REVISION				
REV	DESCRIPTION	DRAWN	APPR	DATE
IR	Initial Registration	I.C.KIM	I.C.KIM	2013.01.10.
1	[설번No.201812-0006]가공개선으로 인한 PCB 시각바디 사이즈 변경 (SQ6.5→SQ6.0)	S.Y.EUN	I.C.KIM	2018.12.28.

TOLERANCE	Decimal	DATE 2018. 12. 28.		 RF & MICROWAVE TECHNOLOGY Tel : 82-32-347-8015 Fax : 82-32-347-8017
	Angle	APPROVED BY	I.C.KIM	
MATERIAL		CHECKED BY		TITLE SMA50 PCB JS-4R
		DRAWN BY	S.Y.EUN	
FINISH		SCALE	5/1	DWG NO. CN01105-7/3
		UNIT	mm	
				REVISION 1
				SHEET 1 of 1

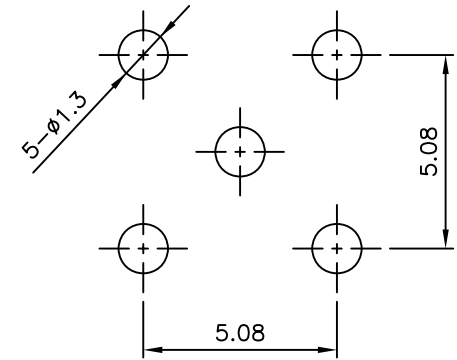
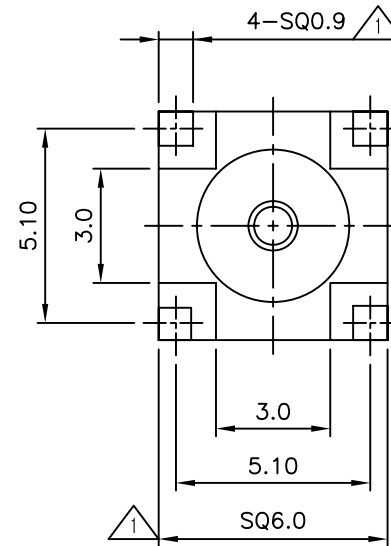
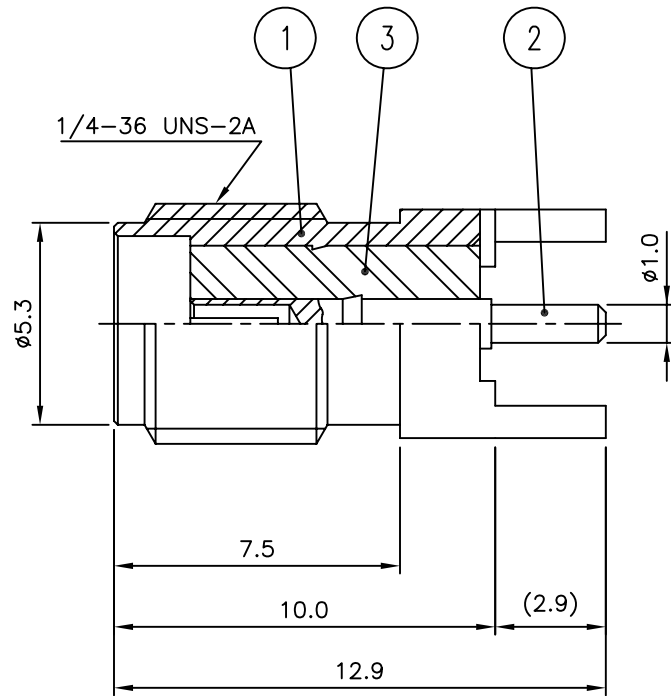
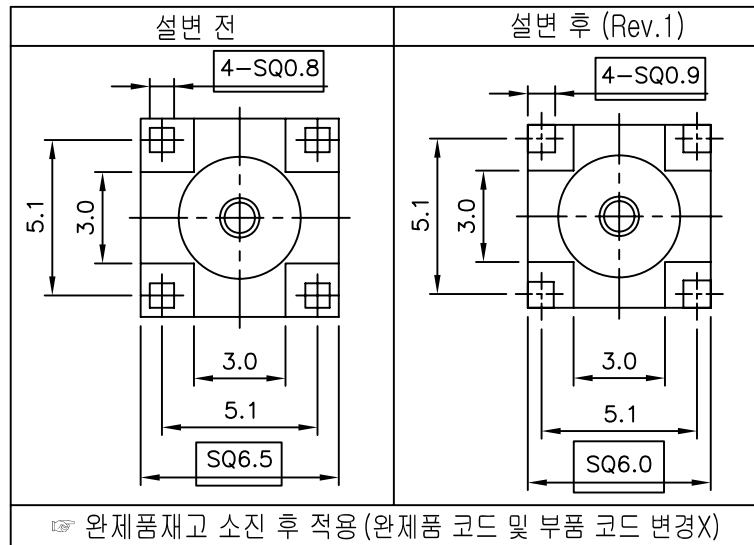
☞ 완제품재고 소진 후 적용 (완제품 코드 및 부품 코드 변경X)
